## **Amendments To The Drawings:**

## REMARKS/ARGUMENTS

Application Serial No. 10/757,196 Reply to Office Action of June 12, 2006

FIG. 1

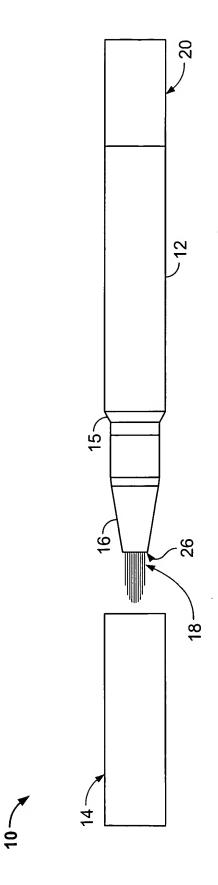
In the Office Action, the Examiner maintained a previously-made objection to the drawings because lead lines in the figures filed in the previous response were not uniformly thick and well-defined. In response, the Applicant has submitted herewith, a new FIG. 1 and a new FIG. 2. No new matter has been added.

Attachments: Annotated sheet for FIG. 1

Replacement sheet for FIG. 1

FIG. ?

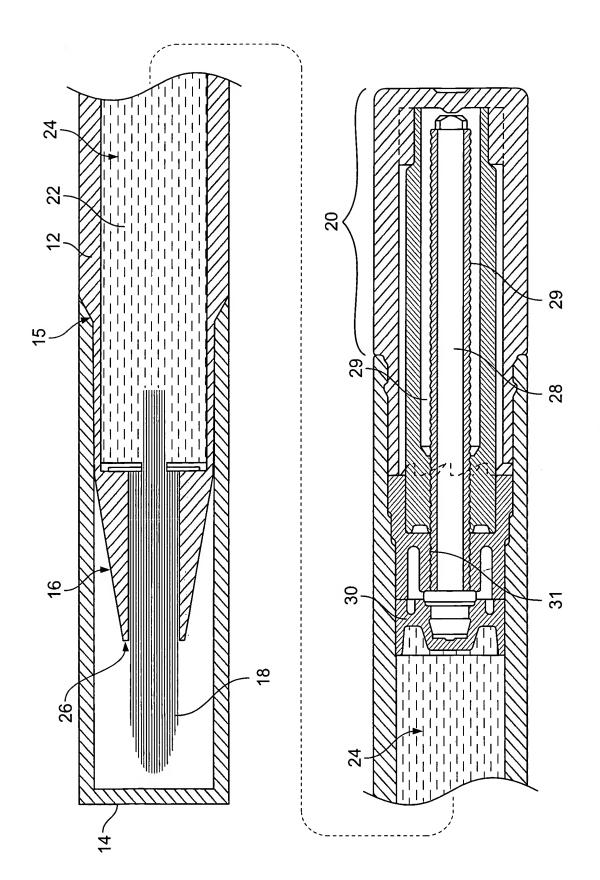
The specification was objected to as failing to provide support for the limitation of claim 1 that recites that the bristles have a first end within the dispensing orifice and a second end located outside of and away from the dispensing orifice. The Examiner noted that on page 5, line 15, the orifice was indicated as reference numeral 26 but in the FIG. 2 that was filed with the last response, the bristles were not depicted as having an end within the part indicated by numeral 26.

New FIG. 2 filed herewith shows bristles (identified by reference numeral 18) with one end located within a dispensing orifice (identified by reference numeral 26). The new FIG. 2 therefore overcomes the Examiner's objection to the specification as not supporting claim 1 is overcome. No new matter has been added by the new figures because the subject matter shown in the new figures, i.e., bristles within the orifice, was clearly disclosed in the original claims and specification.
